# McAlester City Council

### Special City Council Meeting Agenda

1. Consider, and act upon, Change Order No. 8 to the contract with Carstensen Contracting, Inc. for the construction of CIP#4 Improvements and authorize the Mayor to sign Change Order No. 8. (*John C. Modzelewski, P.E., CFM, City Engineer and Public Works Director*)

Consider, and act upon, Change Order No. 8 to the contract with Carstensen Contracting, Inc for the construction of CIP#4 Improvements and authorize the Mayor to sign Change Order No. 8.

# TRENCH DRAIN DETAIL

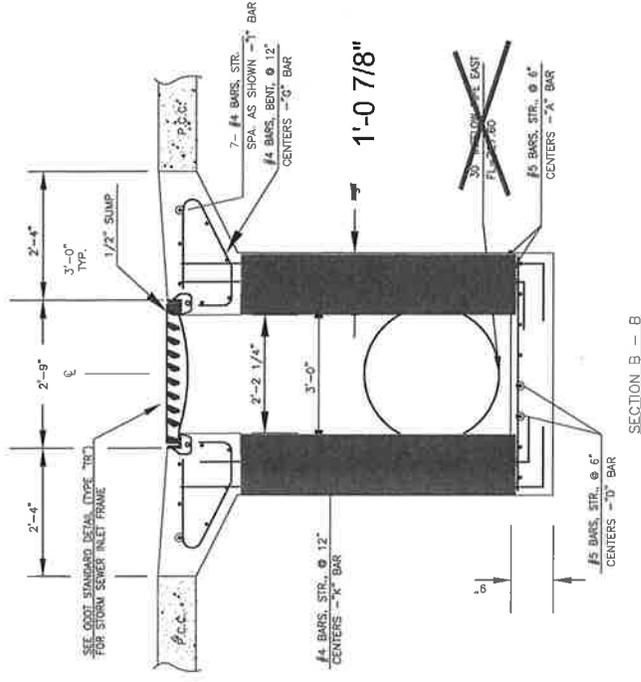
This Change Order includes modifying the trench box constructed across 14<sup>th</sup> Street in order to support the original frame and grate. This is described in the attached form identified as "Carstensen Contracting Extra Cost Detail CIP#4 McAlester."

Can you make the walls thicker? This would add a cubic yard of concrete going from 8" thick to 1'-0-7/8" thick for the length of the trench giving the inside width a uniform 2'-2 1/4" from east to west and there is no longer a pipe on the short side to cause issue with that and you can use the grate/frame you originally selected.

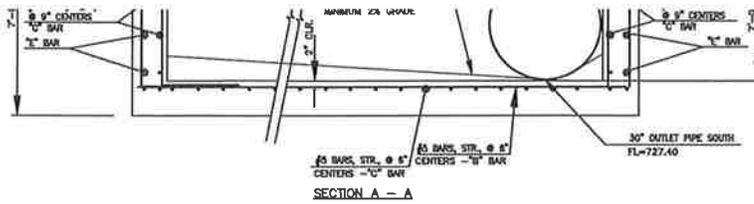
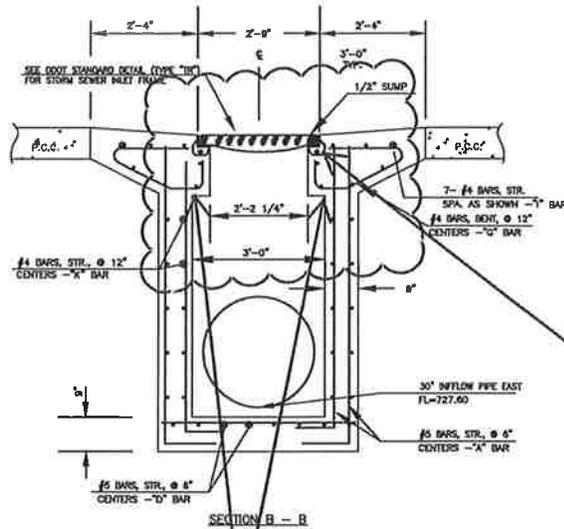
Carstensen Contracting has concern about the design of the trench drain on 14th Street. The way it is designed, the frame and grate site on a small portion of the concrete that has potential to crack and break off, even with rebar in there. Would a frame and grate that sits over top of the entire box or steel I beams across the box to support the frame and grate be a better application? If Poe & Associates feels this is an adequate design we will proceed and install per plan.

Incorporate I-beams across trench to support possible points of concern or add a frame for the grates.

Points of possible failure.

1. Pending City approval prior to work, we suggest added I-beams or a frame for the grates to provide added support and stability to make the grates work together and spread the load along the trench walls.
